**GENOA CHARTER TOWNSHIP
PLANNING COMMISSION PUBLIC HEARING
MONDAY, NOVEMBER 14, 2016
6:30 P.M.
AGENDA**

OPEN PUBLIC HEARING #1...Review of site plan application and impact assessment for an expansion of 34 parking spaces for an existing medical building located at 6888 Grand River Avenue, Brighton. The request is petitioned by Howard Lipkin.

Attention:	Kelly Van Marter, AICP Planning Director and Assistant Township Manager
Subject:	Lipkin Medical Office parking lot expansion – Site Plan Review #1
Location:	6888 Grand River Avenue – south side of Grand River, west of Hubert Road
Zoning:	NSD Neighborhood Services District

**Re: Lipkin Parking Lot
Site Plan Review**

DESIGNED BY: TD
DRAWN BY: TD
CHECKED BY:
SCALE: 1" = 30'
JOB NO.: 13-293
DATE: 4-30-14
SHEET NO.: C5

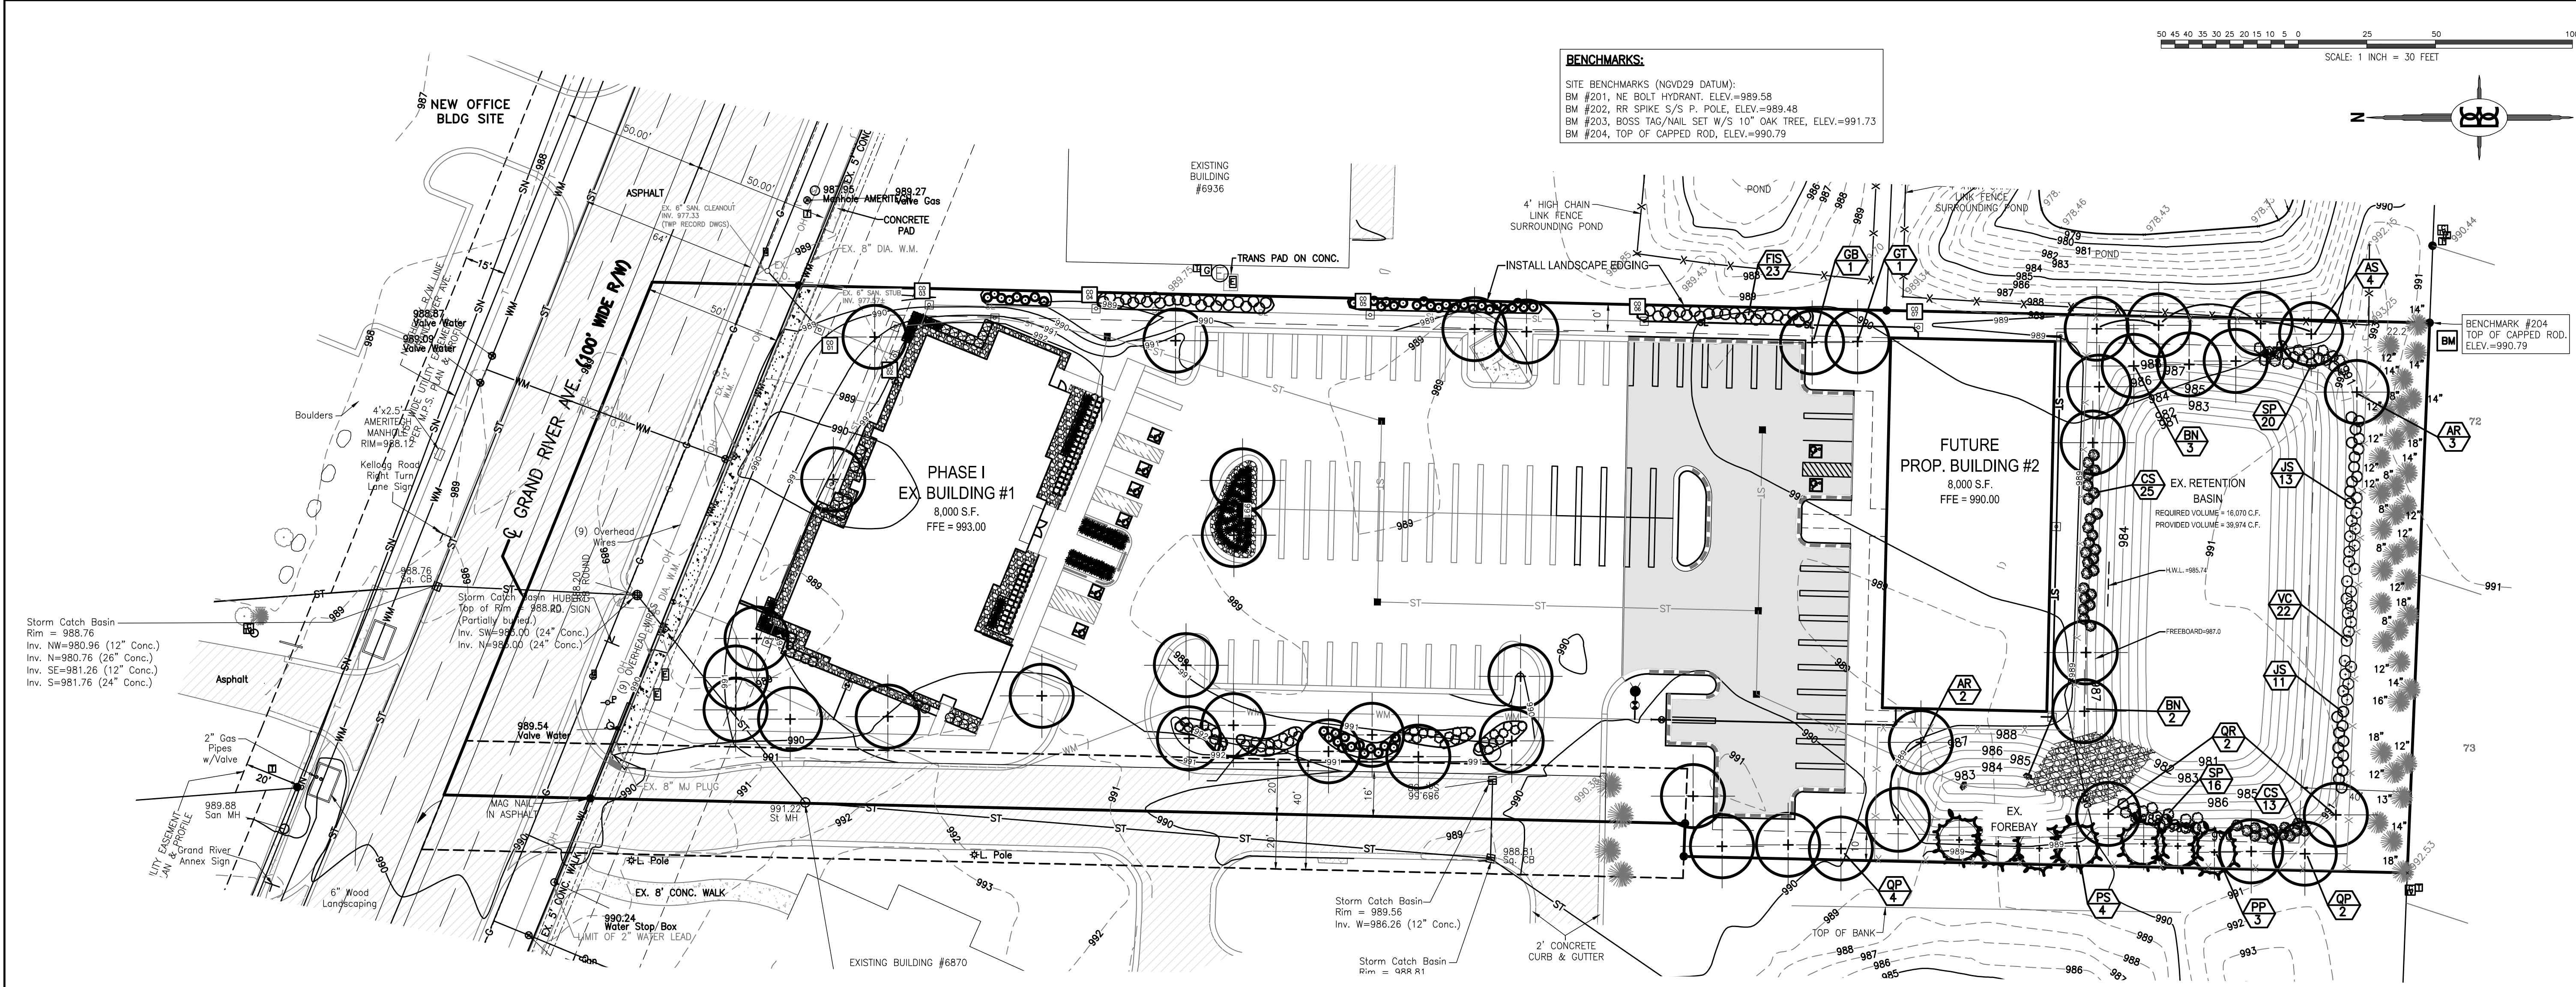
4. The applicant must plant all landscaping that was required as part of Phase I, which is essentially the remainder of the property south of the existing parking lot. We suggest the applicant work with staff to develop a planting plan/schedule to finalize the Phase I landscaping.

5. The landscape plan must be updated to identify existing versus proposed plantings. The parking lot landscaping calculations must also be updated to include the proposed expansion.

We suggest the applicant work with staff to develop a planting plan/schedule to finalize installation of the Phase I plantings. The Commission may wish to include this as a condition of site plan approval for the current request.

Additionally, the plan submitted does not differentiate between existing and proposed plantings and the parking lot landscaping calculations do not include the proposed expansion – this area results in the need for 4 canopy trees and 340 square feet of landscaped area within the parking lot. As such, the landscape plan must be updated to include this information.

DESIGNED BY: TD
 DRAWN BY: TD
 CHECKED BY:
 SCALE: 1" = 30'
 JOB NO. 13-293
 DATE 4-30-14
 SHEET NO. **C6**

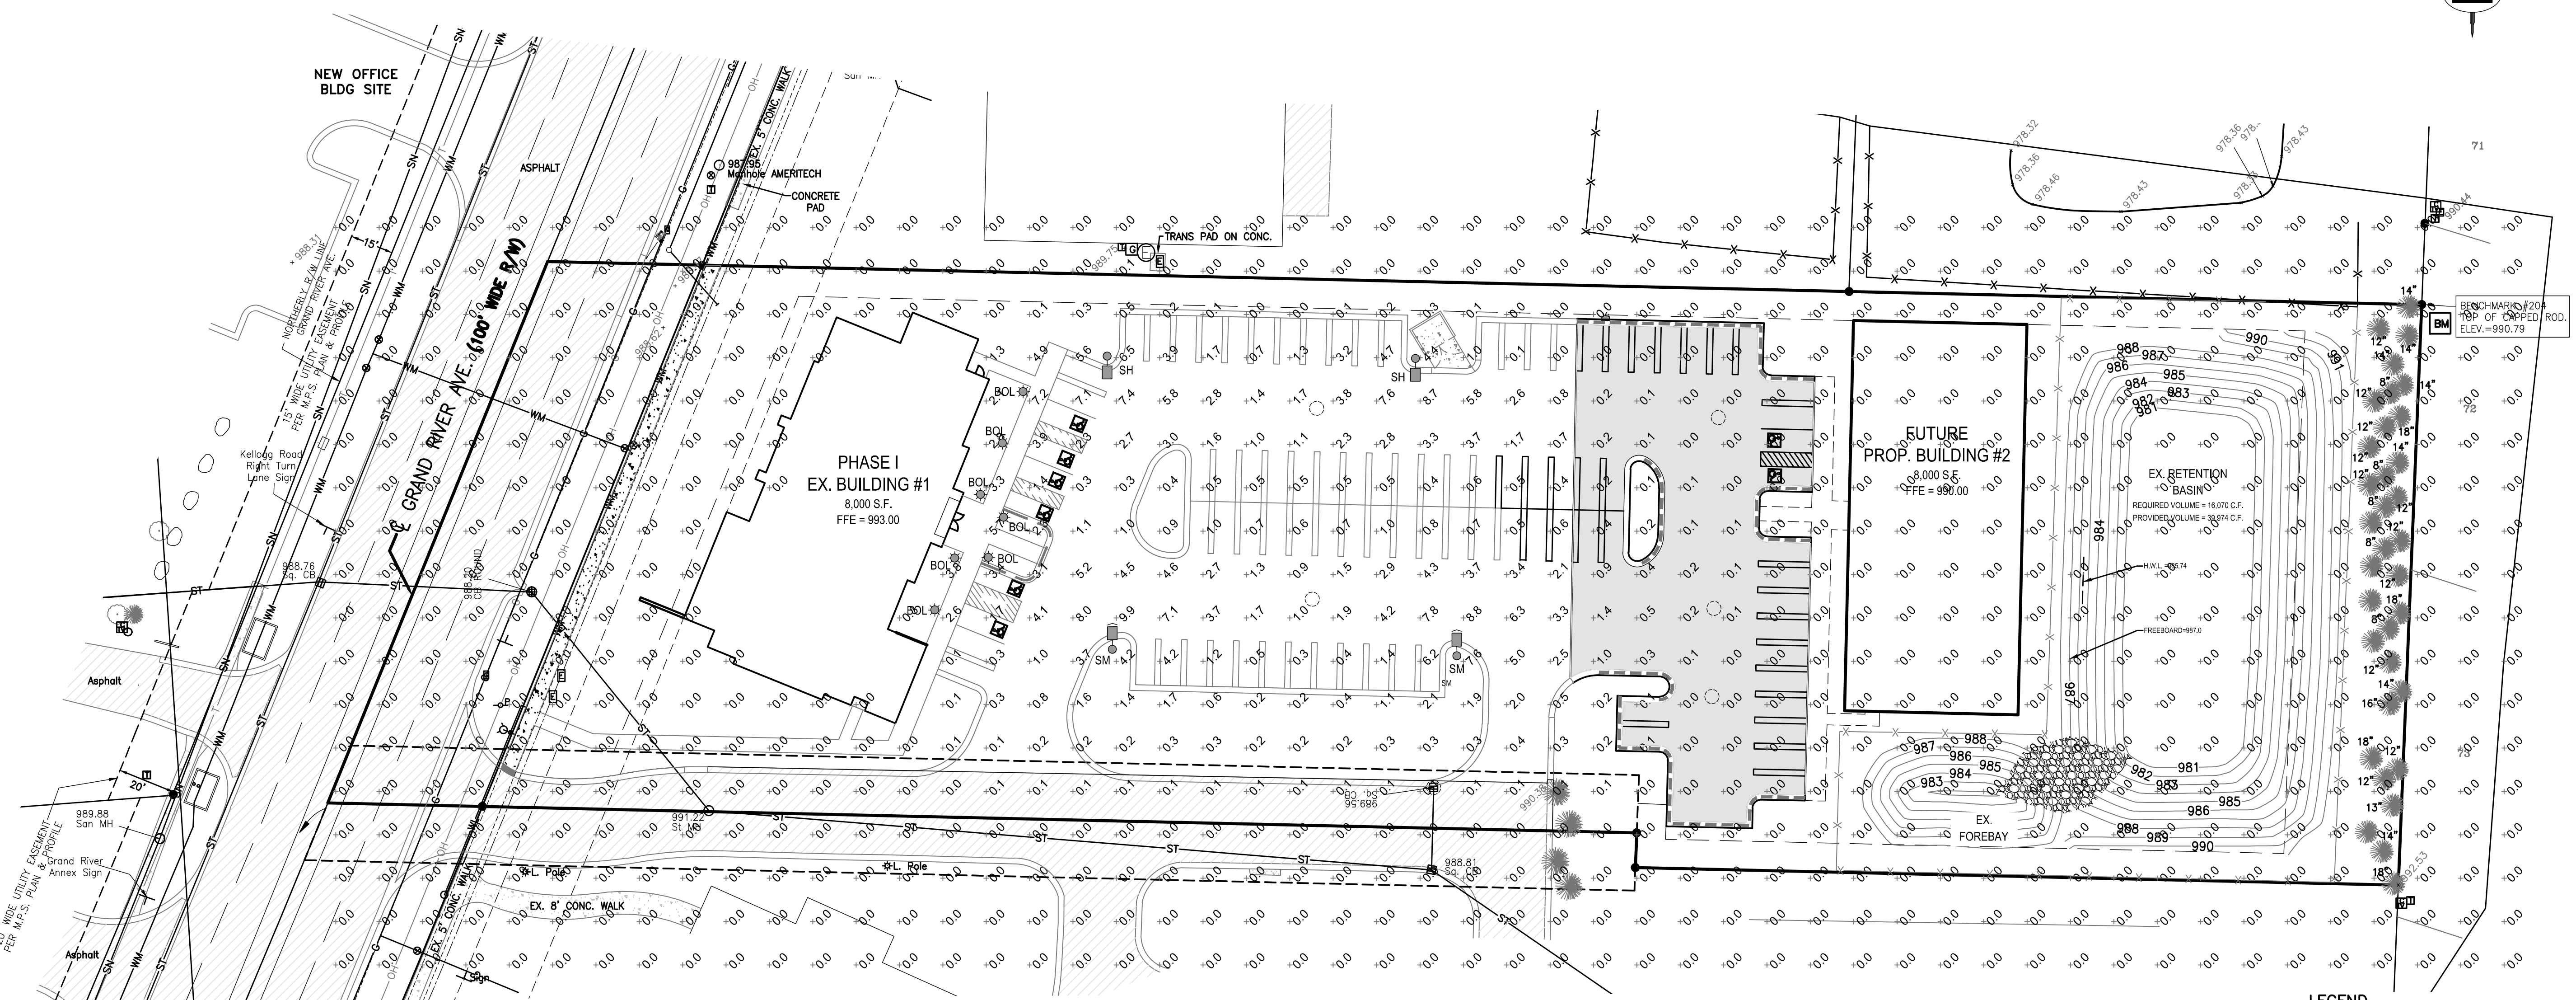
6. The applicant may wish to incorporate new lighting into the expanded parking lot.
7. The Impact Assessment states that 40 new spaces are proposed, while the site plan identifies only 34 new spaces.

9. **Exterior Lighting.** The submittal includes the originally approved lighting plan; however, no new lighting is proposed for the project area. Given that the majority of the readings in the project area are less than 1.0-footcandle, the applicant may wish to incorporate new lighting into the expanded parking lot.
10. **Impact Assessment.** The submittal includes a new Impact Assessment (dated 10/21/16), which notes that the proposed project is not expected to adversely impact natural features, public services/utilities, surrounding land uses or traffic.
